NOTICE OF MEETING
HILLSIDE REVIEW BOARD
CITY OF ST. GEORGE
WASHINGTON COUNTY, UTAH

HILLSIDE REVIEW BOARD AGENDA REPORT: **08/24/2022**

Divario (Formerly “The Lakes”) PA-1

Case No. 2022-HS-014

Aerial of Existing Ridgeline and Ridgeline Setback

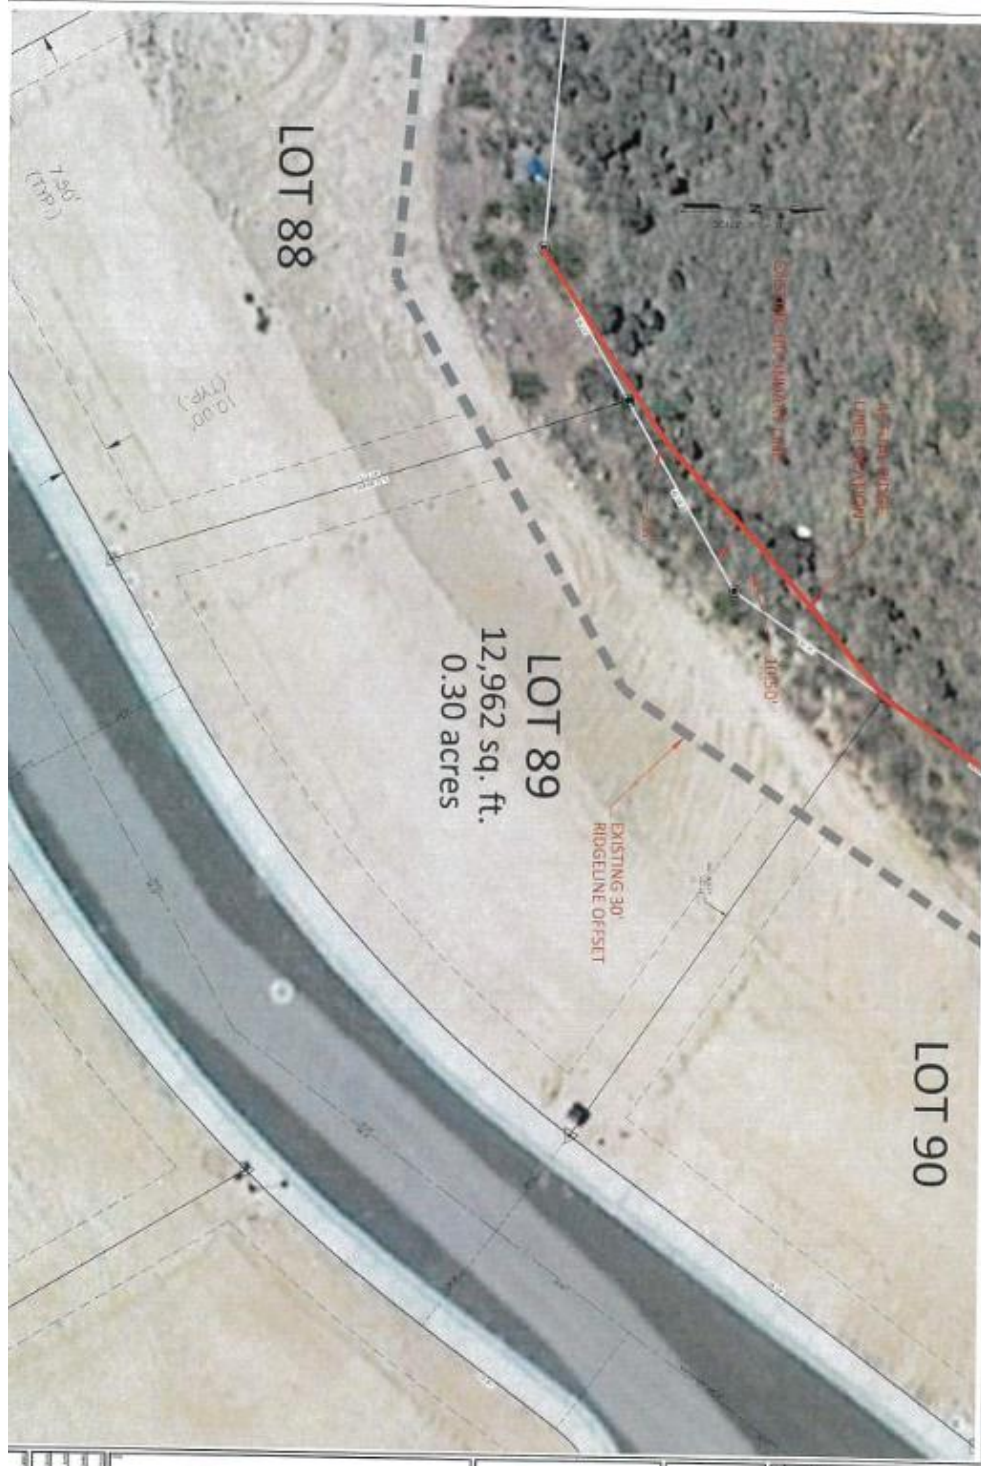
The applicant is proposing to move the location of the ridgeline and the 30' ridge line setback shown on the plat, stating the actual ridge line does not follow the marked line on the plat. They are proposing to move the ridgeline to the west, to follow a line, they feel is the more accurate ridgeline. This will move the ridgeline up to 10.5 feet to the west. The ridgeline setback will remain 30' from the ridgeline but, it will also move to the west. (See Exhibit C and D, Map of Existing and Proposed Ridgeline and Ridgeline Setback) If approved, the applicant will be required to file an amended plat showing the changes. This proposal will keep the property line in the same location and only adjust the location of the ridgeline and ridgeline setback for Lot 89.

Exhibit D Map of Proposed Ridgeline and Ridgeline Setback

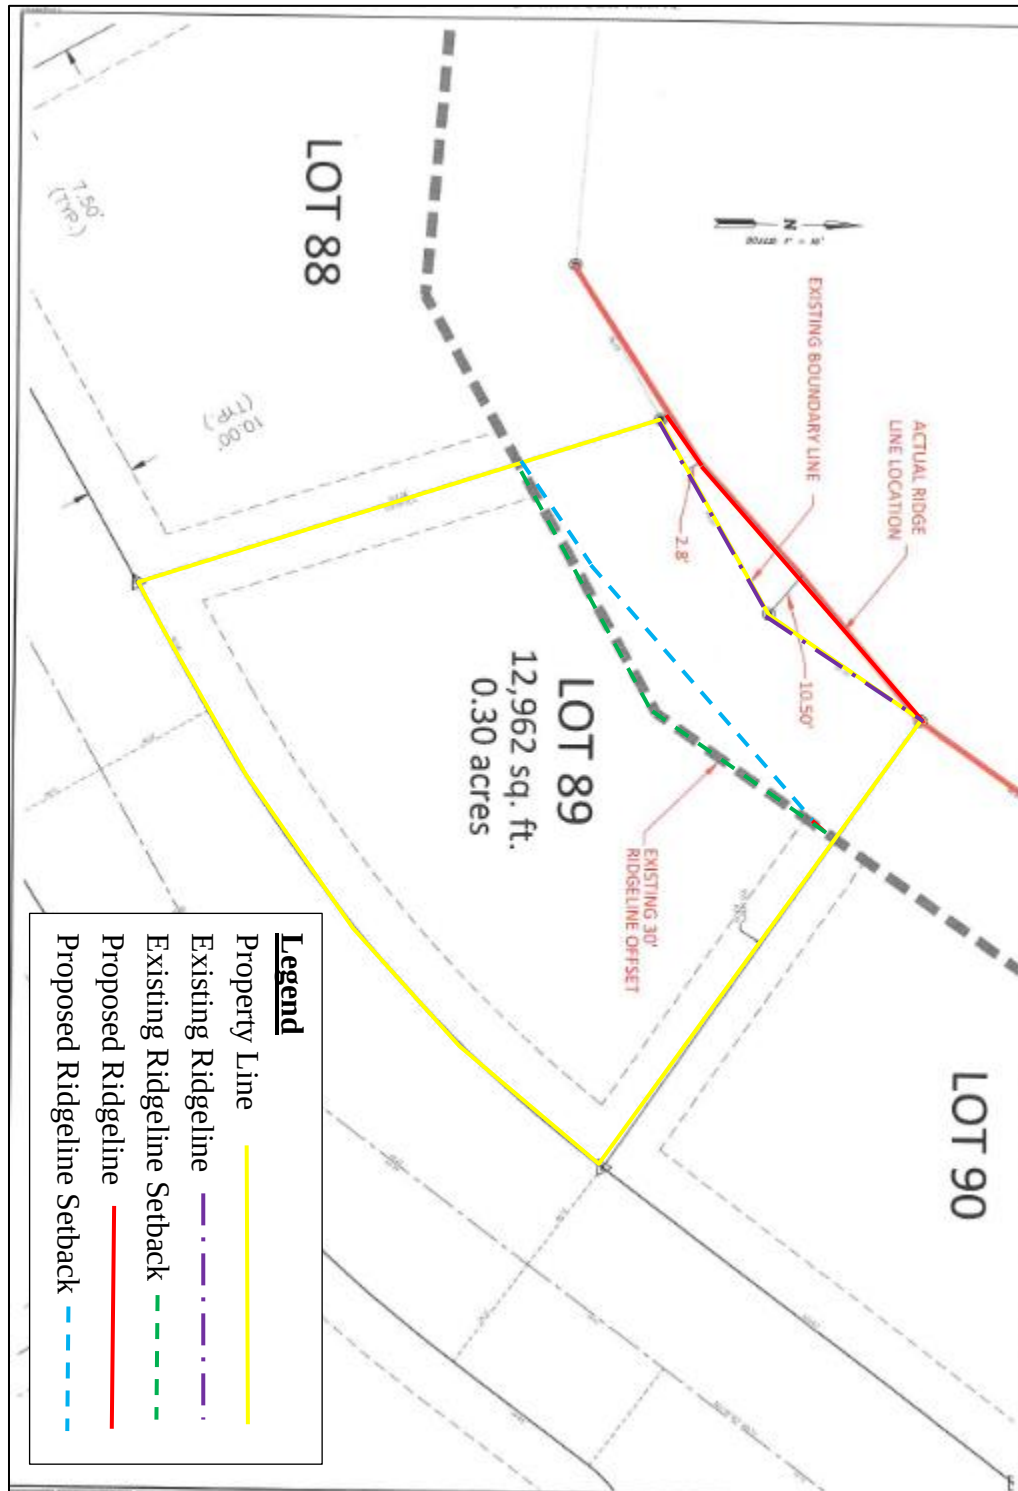
The applicant is requesting that the ridgeline and the ridgeline setback be adjusted for Lot 89 of the South Rim at Foremaster Ridge final plat. If approved, staff recommends to make this conditioned on the following:

1. An amended plat is filed and recorded for Lot 89 of the South Rim at Foremaster Ridge final plat.
